## **RFP 9F030-20200174**

# **Demolition and removal of the D.S. Kennedy Radio Astronomy Antenna Addendum #1**

**Schematic Detail of Concrete Base Roof-to-Wall Joint**

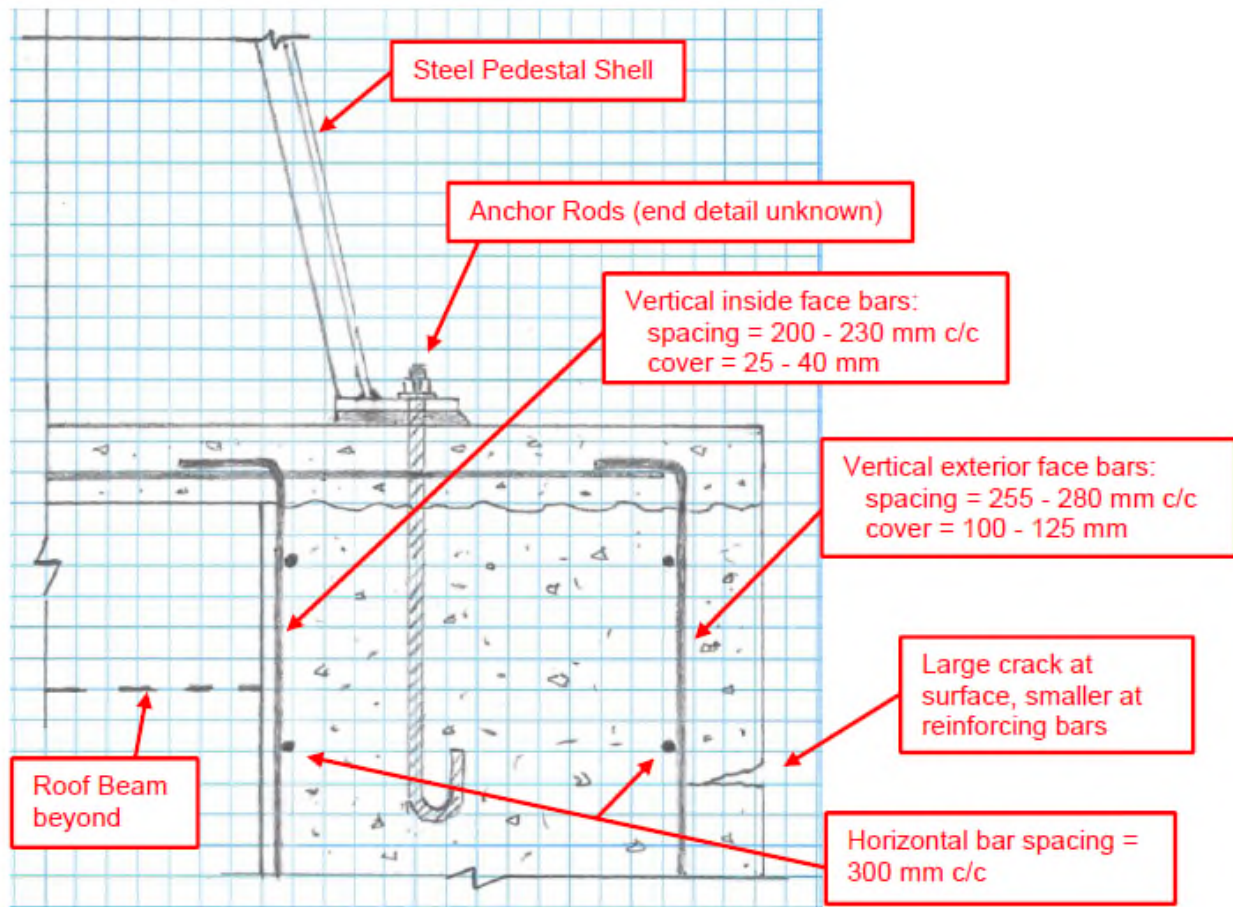
Existing drawings from the original construction of the dish are not available. Approximate dimensions are provided below:

Height of structure – Approximately 24.m to 27.4m

Width of Dish Section – 18.3m

Octagonal Concrete foundation walls – 813mm thick

Sketch of wall profile below:
